VILLA ORCHIDS

Details of Additions & Alterations

Villa No	294	Type	Deluxe / Semi-Deluxe
Buyer Name	Mr. B. Rajeshwar Rao		
Phone No.	9100596155	Email

GROUND FLOOR

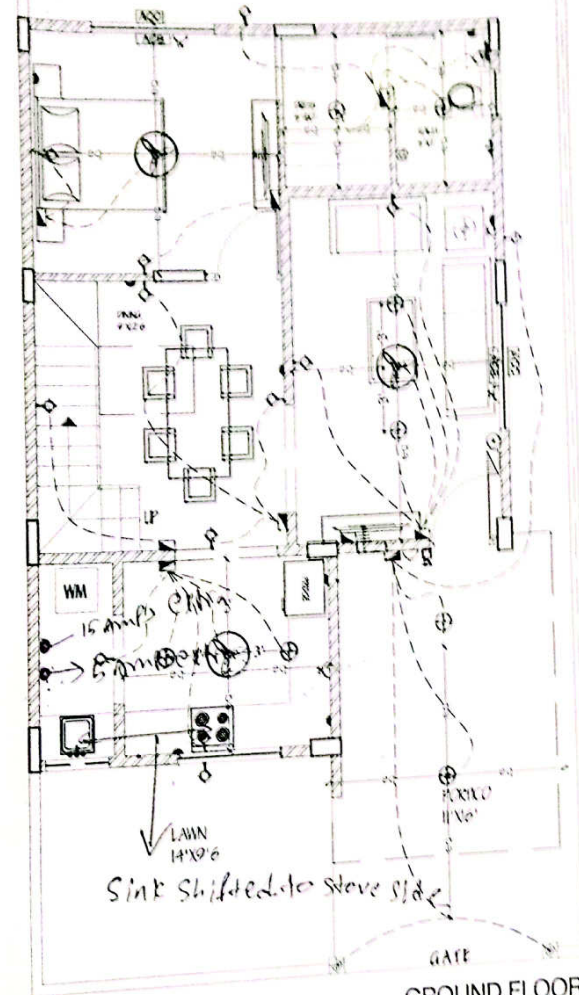
✓ In Master Room 10 Amp & 5 Amps extra points as per Plan

- ✓ In Kitchen South side wall Recess w/Basin form
for Bowl type wash basin Recess Inlet & Outlet as per Plan
- ✓ @ Ground floor Dress Area Recess for washing machine
Point as per Plan
- ✓ Sink shifted towards Side as per Plan
- ✓ In Terrace Top Recess

Ø L Shape Platform Reconfigure as per Drawing
North wall to Platform Reconfigure ~~with~~ 3'6" Gate as per Plan

Ø Around floor dress Area require extra Door as per Plan
Ø Kitchen & Utility wall should be removed as per Plan
